# UNITED STATES PATENT AND TRADEMARK OFFICE

| APPLICATION NO.             | FILING DATE | FIRST NAMED INVENTOR | ATTORNEY DOCKET NO. | CONFIRMATION NO. |
|-----------------------------|-------------|----------------------|---------------------|------------------|
| 10/743,983                  | 12/22/2003  | Larry E. McKinley    | ITDE-PNV112US       | 9056             |

| <b>Office Action Summary</b> | <b>Application No.</b><br>10/743,983 | <b>Applicant(s)</b><br>MCKINLEY ET AL. |  |

Fig.12

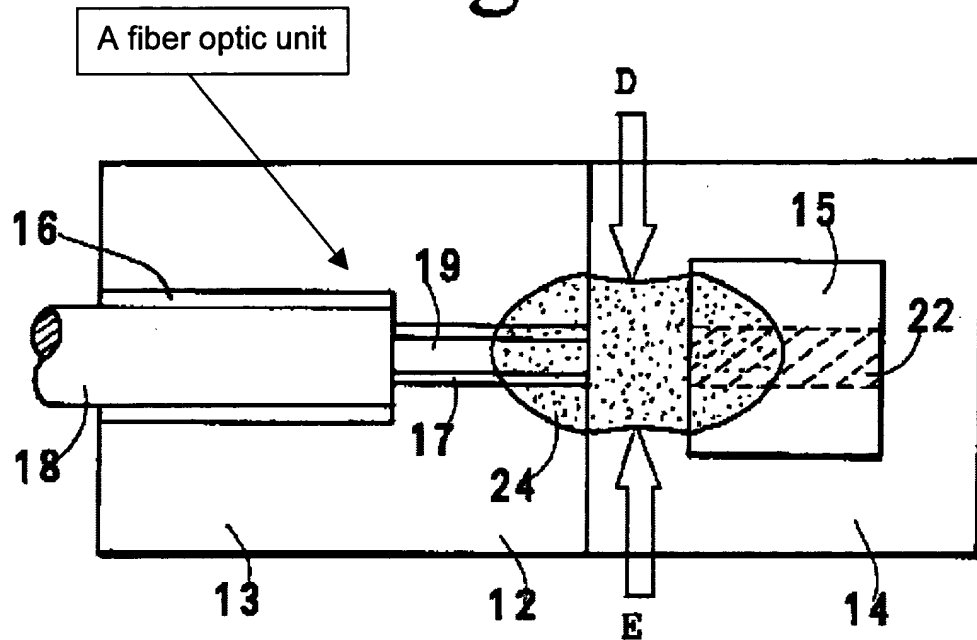
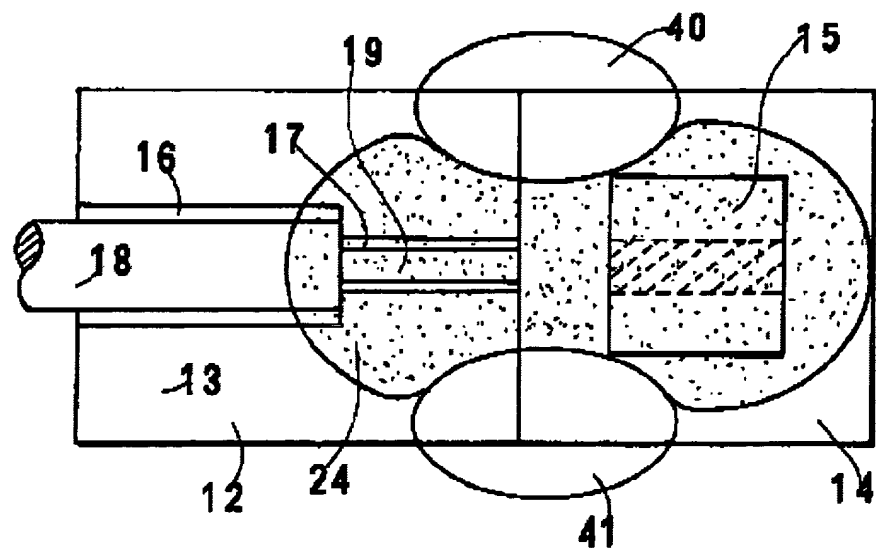
5. Claim 10 is rejected under 35 U.S.C. 102(e) as being anticipated by Kuhara et al. (U.S. Patent 6,733,190).

With respect to claim 10, Kuhara et al. (figures 12 and 15) disclose a device for mounting a fiber optic unit to a photosensor, the device comprising a photosensor (15) mounted to a first carrier (14) (column 2, line 10); a fiber optic unit (see figure 12) coupled to the photosensor (15) to create a joint between the photosensor and the fiber optic unit (column 2, line 35) and a force applying means (24, 40 and 41) coupled to the photosensor (15) and the fiber optic unit for applying a compression force to the joint (column 7, lines 24-28).
